Application of D.A. Edwards & Company c/o Dennis J. Webb, Jr., Smith, Gambrell & Russell to rezone property from R-75 (Residential Medium Lot) zoning district to RSM (Residential Small Lot Mix) zoning district to allow the construction of cottage-style urban single-family detached homes, at 1251 Robinwood Road.

PETITION NO: Z-22-1245936 (2022-2253)

STAFF ANALYSIS

SUBSTITUTE

A100.3

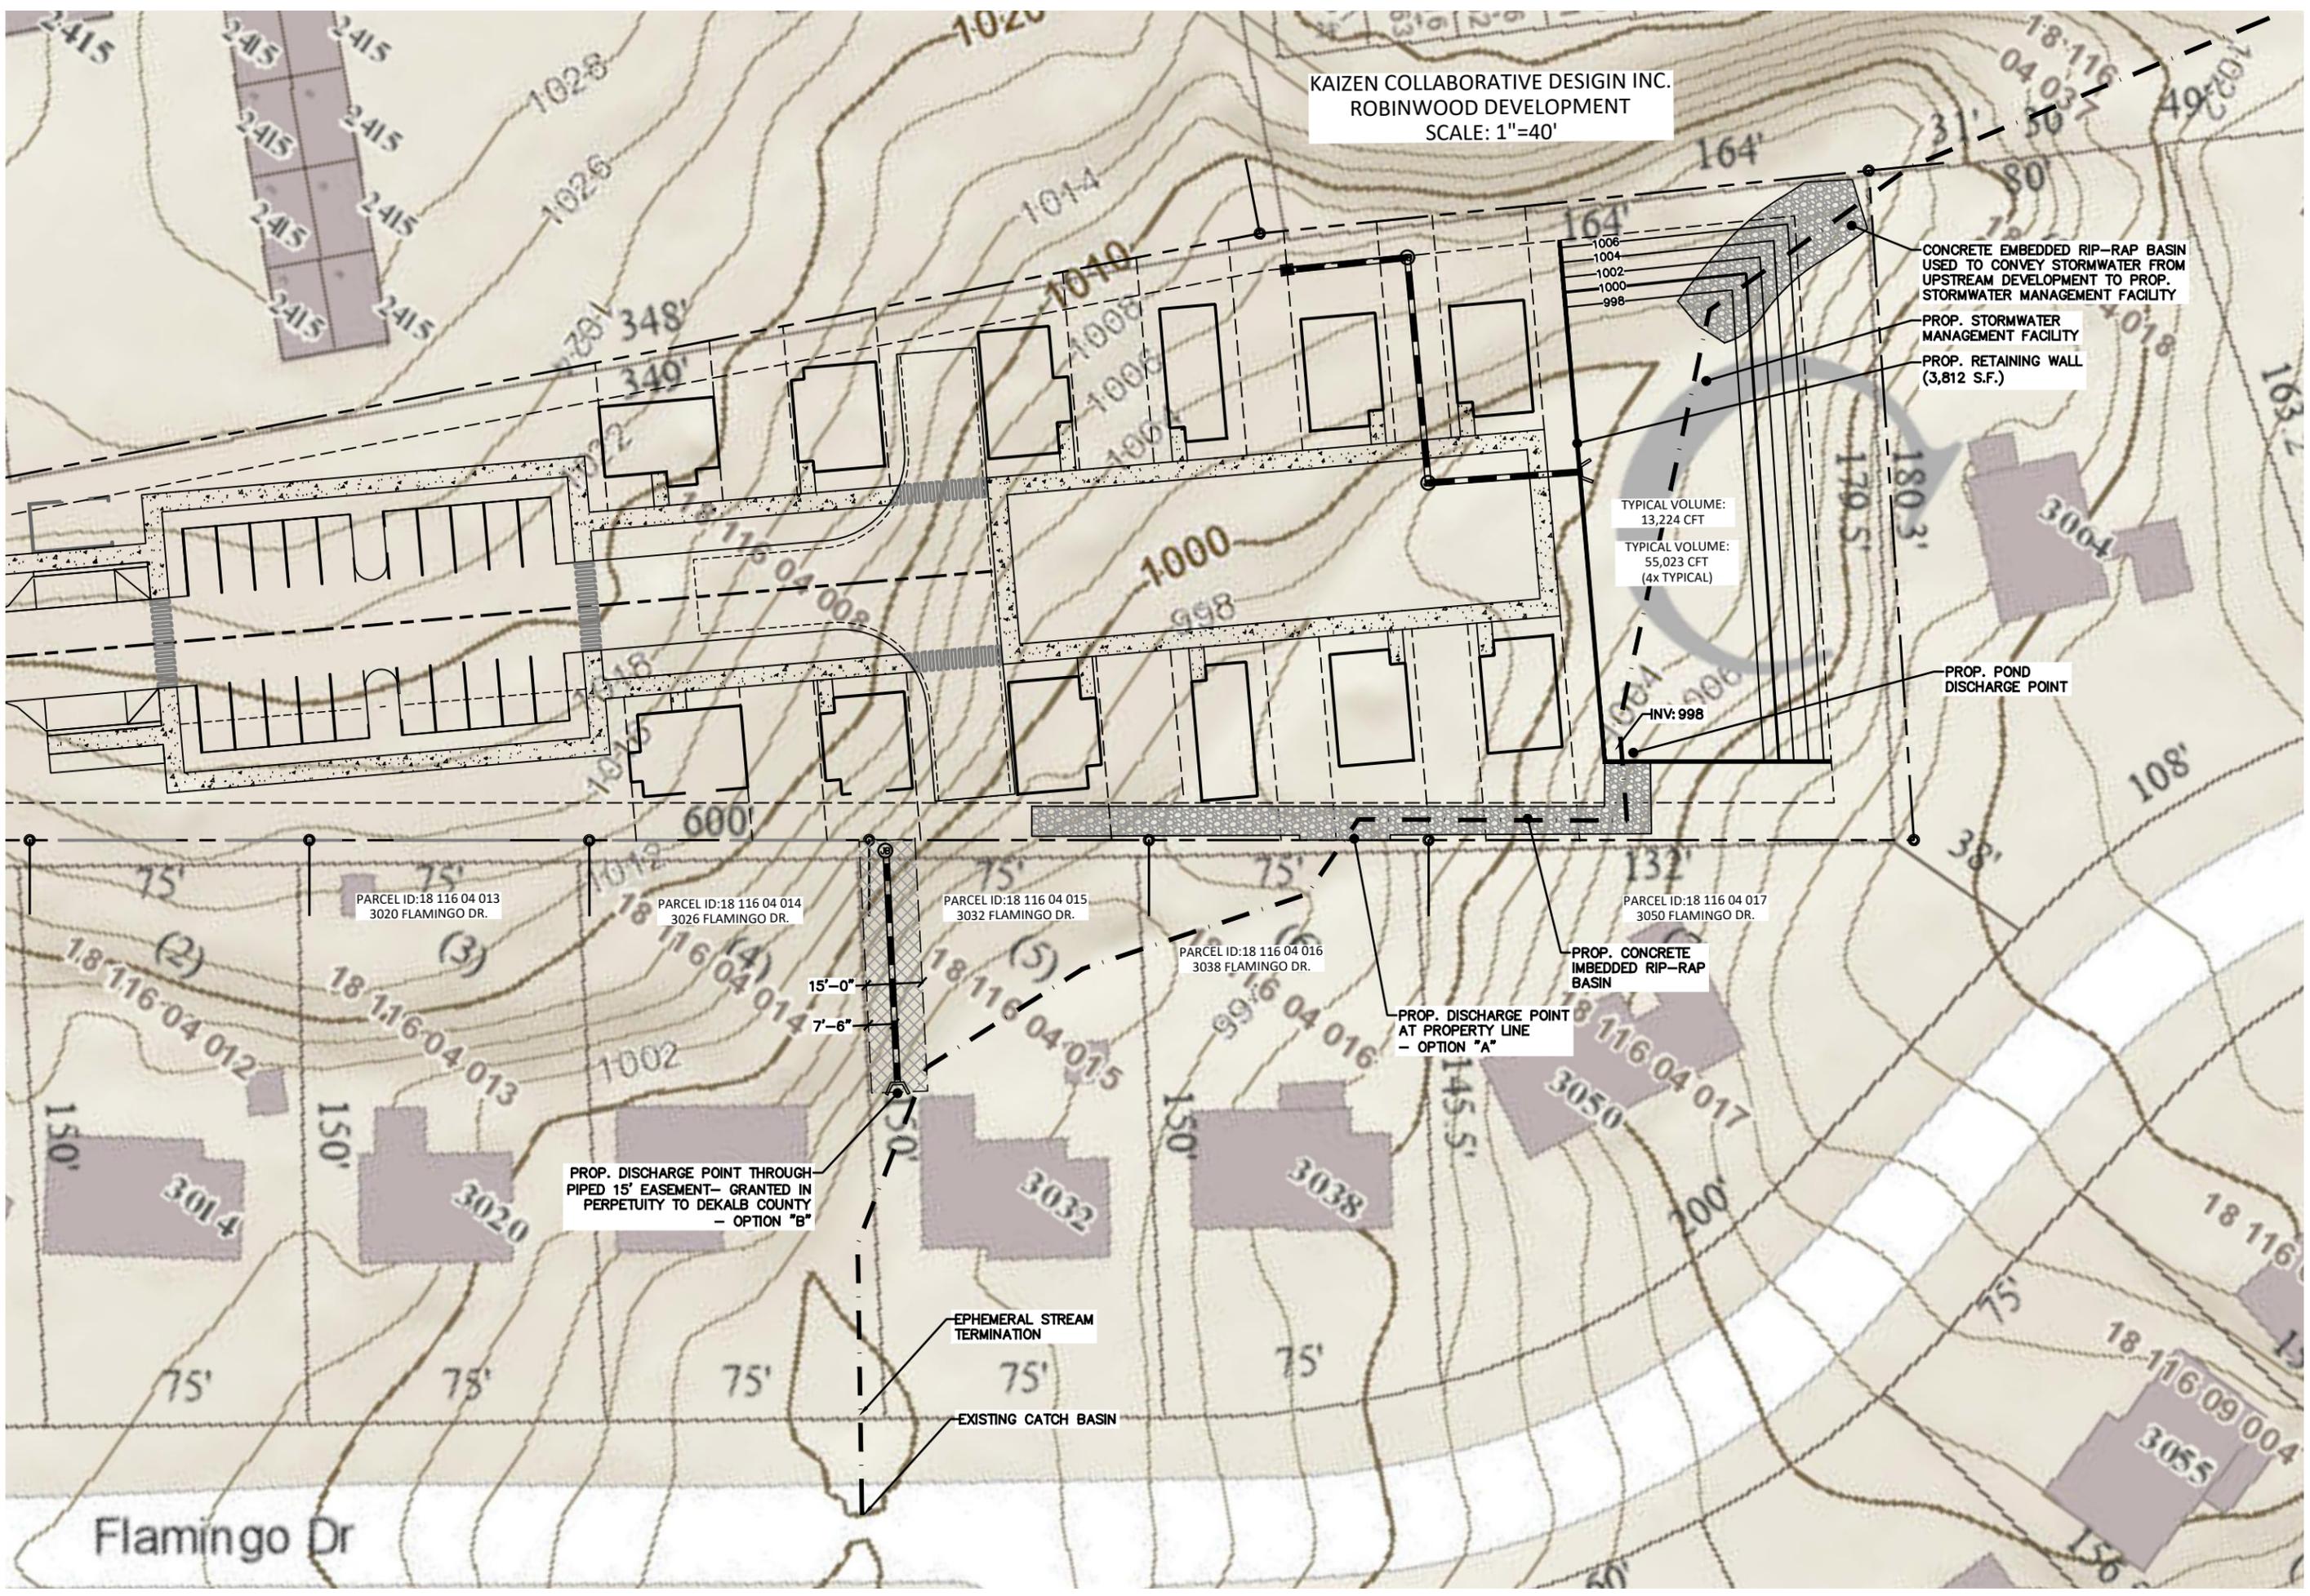
The request was deferred from the February 28, 2023 Board of Commissioners (BOC) meeting. Since the November 17, 2022 BOC Zoning meeting, the applicant has submitted a revised plan (see attached) for the proposed 16 cottage home development which addressed most of the concerns raised in the previous Staff Report as follows:

1. Applicant has increased the unit sizes from 550 square feet to 800 square feet with a maximum building height of 1.5 stories to comply with the current cottage development standards in the Zoning Ordinance;

2. The Applicant indicates that the Plan will provide for a minimum of two fee-simple lots in order to qualify for density bonuses to obtain the desired density of 8 units per acre;

3. The Plan provides for one tree for every 8 parking spaces and a 5-foot wide landscape strip around the perimeter of the parking lot to comply with the parking lot landscape requirements of the zoning ordinance;

4. The Plan provides a 10-foot wide easement along both sides of the proposed private drive to comply with the private drive requirements of the zoning ordinance;

5. The Land Development Division has reviewed the revised plan and finds the *conceptual* drainage plan acceptable, subject to compliance with the County's Stormwater Management regulations prior to issuance of any Land Development Permits.
